CORRECTIVE WORK NEEDED FOR THE
REHABILITATION OF THE HEADWATERS OF THE
REDWOOD CREEK WATERSHED

David M. Burns & Perry Y. Amimoto
April 1977

ATTACHMENT "A"

COMMENTS KEYED BY NUMBER TO TEXT

Fig. 5. Ephemeral streams are generally clogged with old logging debris which have acted as debris catchment basins.

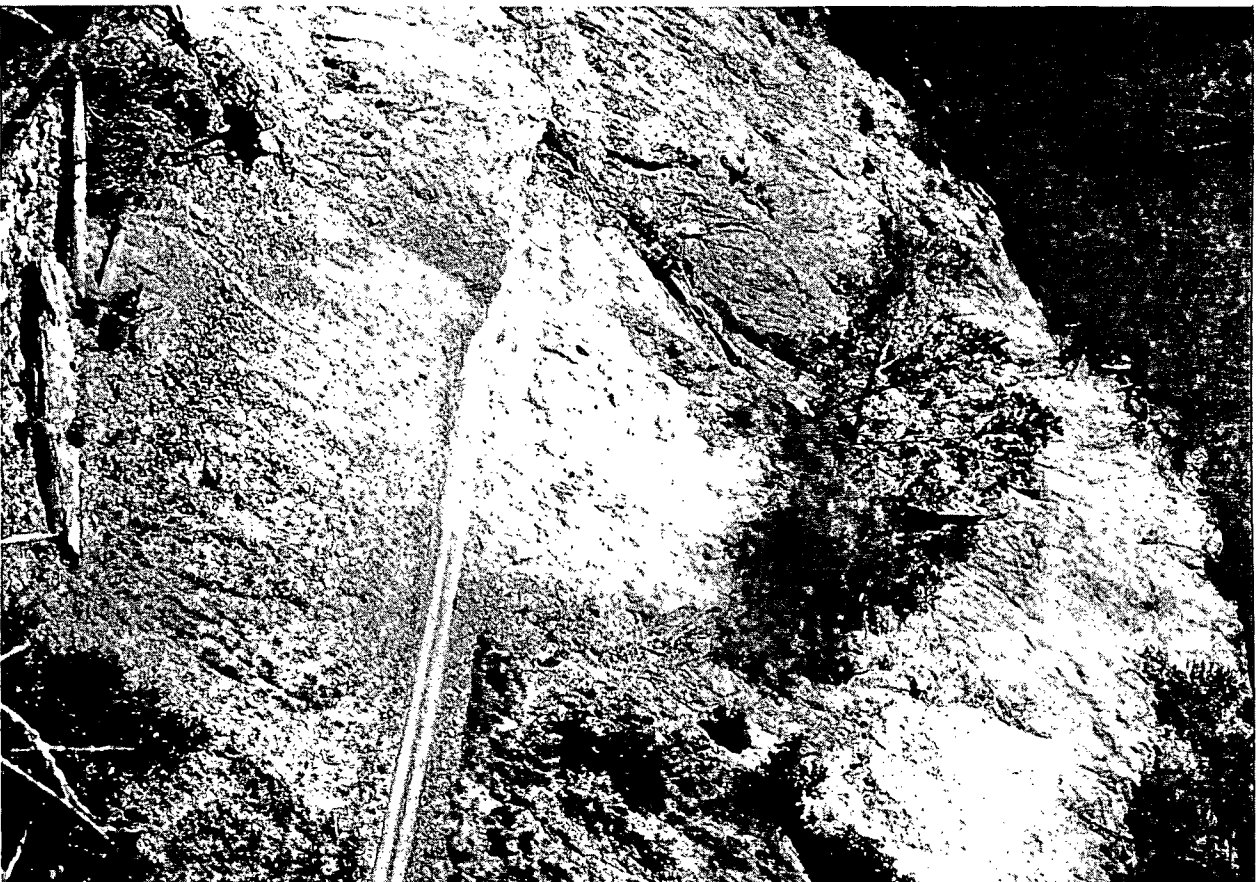
This is described more as a sink than a source.

The section on Source of Debris and Sediment would benefit from a reorganization of the findings. For instance, item 3 as described is not now an active source of sediment; it describes areas in which debris and sediment have become stored and at least temporarily withheld from further transport. It would be appropriate to add an item related to debris jams in perennial streams. Items 1 through 6 refer to timber harvest related sources while item 7 and the following paragraph introduce partly natural sources and potential impacts of future development. While such development must be considered in future watershed management coordination, it is a separate item from the rehabilitation program. Reorganization of this section would permit the mitigating measures discussed in the next section to be related to the corresponding problems under Sources. It would also be useful to estimate volumes of sediment now in stream channel storage, as a means of relating active sediment sources to the average annual sediment load (1954-75) at the Redwood Creek near Blue Lake station, which is 780,000 tons per year (18 tons/acre/yr).
